UNITED STATES PATENT AND TRADEMARK OFFICE

Office Action Summary	Application No. 10/602,253	Applicant(s) AKRAM, SALMAN	
	Examiner Leonardo Andújar	Art Unit 2826

DETAILED ACTION

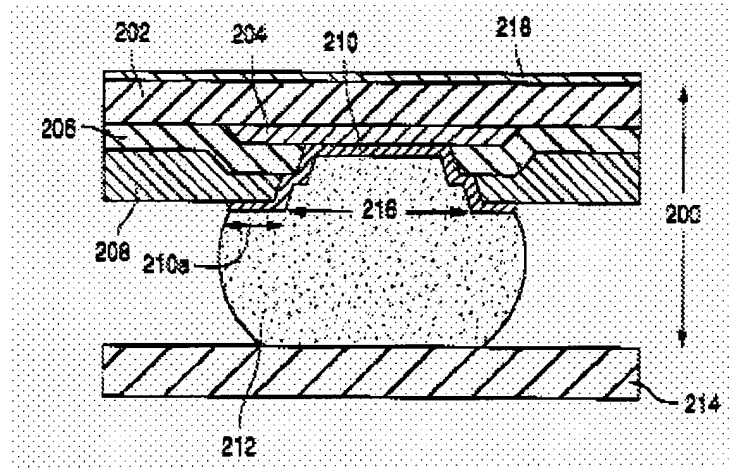
6. Regarding claim 1, Schaefer shows most aspects of the instant invention including a semiconductor substrate 202 having a conductive trace; a passivation layer 206/208 and a metal lined via 210 in the passivation layer and in electrical communication with the trace. Schaefer shows that the external electrode 212 overlaps the electrodes 204 (fig. 2 & col. 5/lis. 41-44).

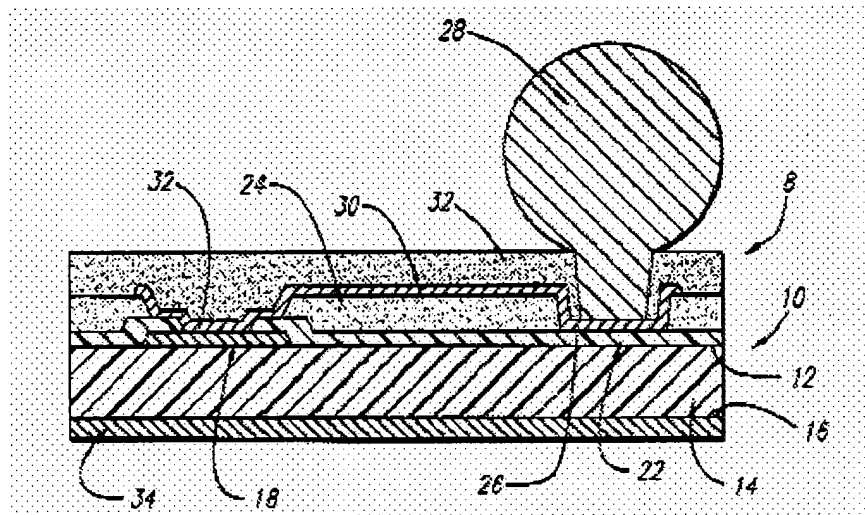
7. Schaefer does not show that the conductive trace is over a dielectric layer. Elenius (e.g. figs. 1 and 2) shows a semiconductor substrate 14 having a dielectric layer 22 on an exposed surface, a conductive trace 30 on the dielectric layer and a passivation layer 24 over the conductive trace. According to Elenius this type of embodiment provides an improved chip scale package that has a small form factor, i.e. the resulting chip scale package is not larger than the size of the original integrated circuit (col. 3/lis. 16-41). Elenius discloses that the size and the amount of the solder bumps are compromised due to the fact that the solder pads are typically located at the

perimeter of the integrated circuit. The solder bump contact pads can be redistributed internally, away from the outer perimeter of the integrated circuit; the size of such solder bumps is unchanged. Therefore, the requirements of complex integrated circuits can be fulfilled (col. 2/lis. 25-40).

It would have been obvious to one of ordinary skill in the art at the time the invention was made to provide the conductive trace disclosed by Schaefer over a dielectric layer to provide an improved chip scale package having a small form factor, i.e. the resulting chip scale package is not larger than the size of the original integrated circuit, and to internally redistribute the solder bump contact pads, away from the outer perimeter of the integrated circuit, in order to fulfill the requirements of complex integrated circuit as taught by as taught by Elenius.
